Re: **Request for Access to Records under the Freedom of Information and Protection of Privacy Act (the "Act")**

Records (including forms, application materials, letters of assurance, and/or decisions) related to any applications to the City of Vancouver with respect to DP-2020-00781 at 2720 Ward Street which include for Zoning and letters of assurance. Date range: January 1, 2017 to January 11, 2022.

From: ["Greig, Zoë" <Zoe.Greig@vancouver.ca>](mailto:Zoe.Greig@vancouver.ca)
To: ["Choi, Nicole" <Nicole.Choi@vancouver.ca>](mailto:Nicole.Choi@vancouver.ca)
["Szeleczyk, Oliver" <Oliver.Szeleczyk@vancouver.ca>](mailto:Oliver.Szeleczyk@vancouver.ca)
CC: ["McAuley, Jordan" <Jordan.McAuley@vancouver.ca>](mailto:Jordan.McAuley@vancouver.ca)
["Embley, Erin" <Erin.Embley@vancouver.ca>](mailto:Erin.Embley@vancouver.ca)
["Farmand, Saba" <Saba.Farmand@vancouver.ca>](mailto:Saba.Farmand@vancouver.ca)
["Neufeld, Justin" <Justin.Neufeld@vancouver.ca>](mailto:Justin.Neufeld@vancouver.ca)
Date: 2/23/2021 12:38:06 PM
Subject: RE: 2720 + 2726 Ward Street - DP-2020-00781 Conditions

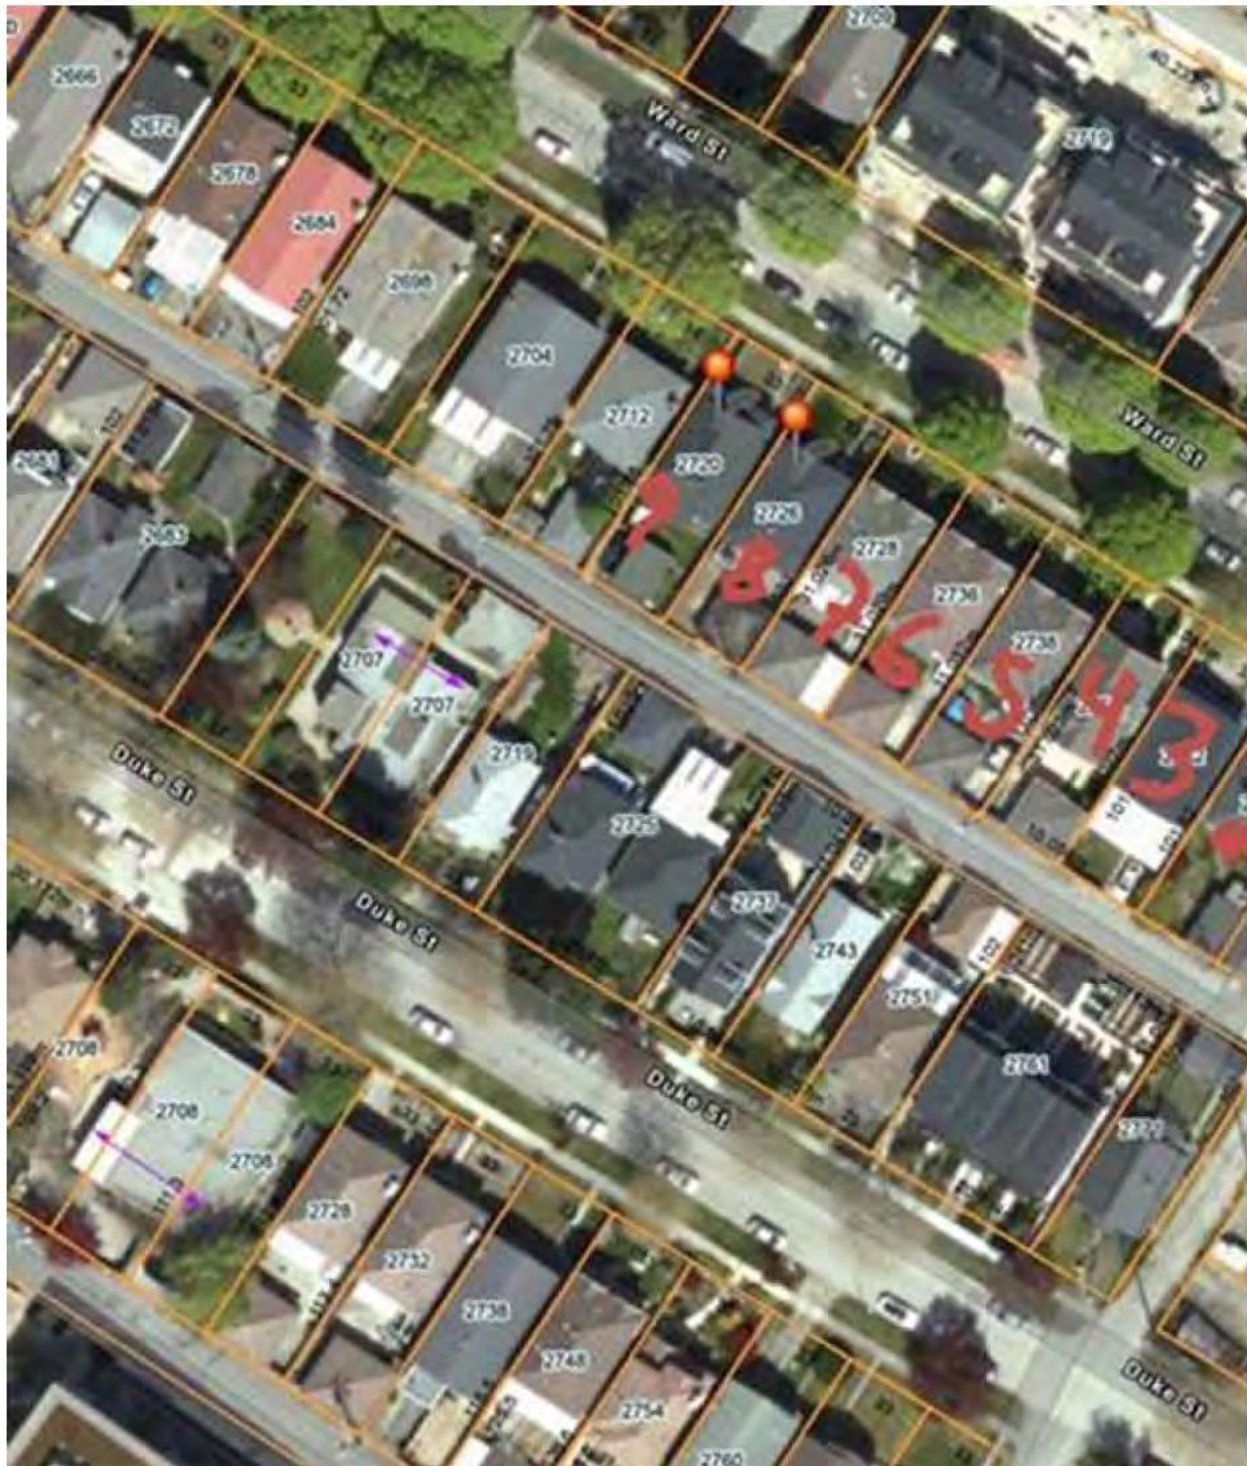
I was preparing my conditions for this noticed that our site may apply to Section 10: . Special Considerations for Development Along Ravine Way Linear Park in Norquay of the RM- 7 Design Guidelines.

Thanks for your patience while I looked into this further. I've confirmed that the subject assembly won't be required to provide a setback as it is far enough away from the future linear park. Please note that Ravine way remains a long-term ambition, so big thanks to those who brought this to everyone's attention.
